## Product Change Notification

**1. ECR #:** 173451  
**Notification #:** 429

**3. Series:**  
• LPAM - LPAM TERMINAL ARRAY ASSEMBLY

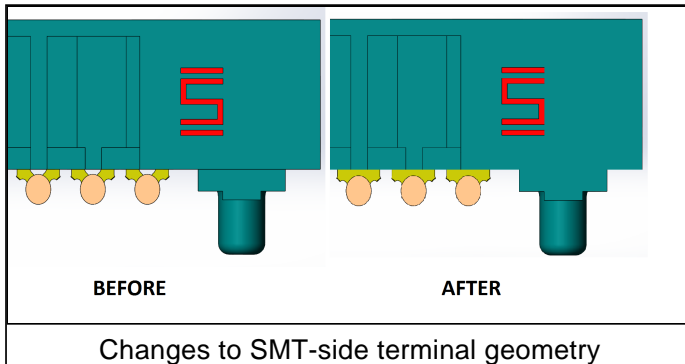
**5. Description of Change:**  
Changes to SMT-side pin geometry

**7. Reason for Change:**  
In an effort to continually improve products, Samtec has revised LPAM pin geometry. All changes are backwards compatible with existing LPAX. Orders may contain connectors with and without these modifications until inventory is depleted. The void above the solder crimp on the SMT-side of the terminal was removed to improve visual consistency of the solder-joint when inspected by X-ray.

- Form - SMT-side terminal geometry will have a small void removed, just above the solder crimp
- Fit - Changes are backwards compatible with all existing LPAX; no change to overall size or footprint
- Function - The anti-wicking laser-score capability was improved to include all sides of the stamped pin
